| SUBJECT: LOWER BALL JOINT — SAFETY RECALL CAMPAIGN | | | No: SR-01-007 |
| | | | DATE: March, 2001 |

| SUBJECT: | | No: SR-04-001 | |

This bulletin supercedes SR-01-007, issued March, 2001, for revised ball joint inspection procedures.

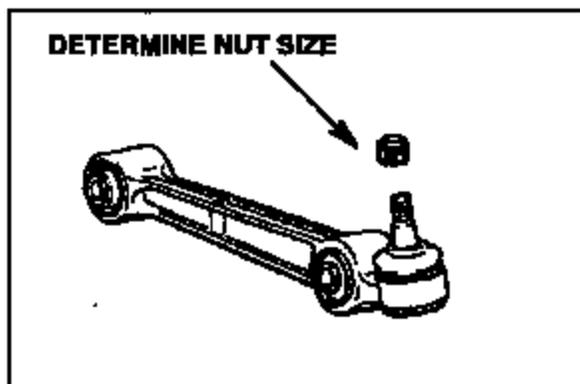
- h. Use a rope to suspend one of the vehicle's tires from the rotor as shown. The weight of the tire will bottom out the ball joint.

- i. Place the tip of an approximately 10" long (270 mm) pry bar to the flat side of the knuckle between the lateral lower arm and the compression lower arm.

Using the shock absorber fixing bolt as a pivot, apply 44 lbs. (20 kg) of force downward on the pry bar. Note any dial indicator movement. Then release the force on the pry bar and note any dial indicator movement. Record the dial indicator reading for the warranty claim.

- For 28 - 30 mm diameter end cap ball joints, replace the lower lateral arm assembly if the ball joint free play is greater than 0.5 mm (0.0197 in.). Go to Step 5.
 - For 32 - 35 mm diameter end cap ball joints, replace the lower lateral arm assembly if the ball joint free play is greater than 0.1 mm (0.0039 in.). Go to Step 5.
 - If the ball joint free play is within specification (0.5 mm or less for 28 - 30 mm end cap diameter; 0.1 mm or less for 32 - 35 mm end cap diameter), go to Step 6 for sealant application instructions.
- j. Repeat Steps e. through i. on the other side of the vehicle. Then remove the dial indicator.
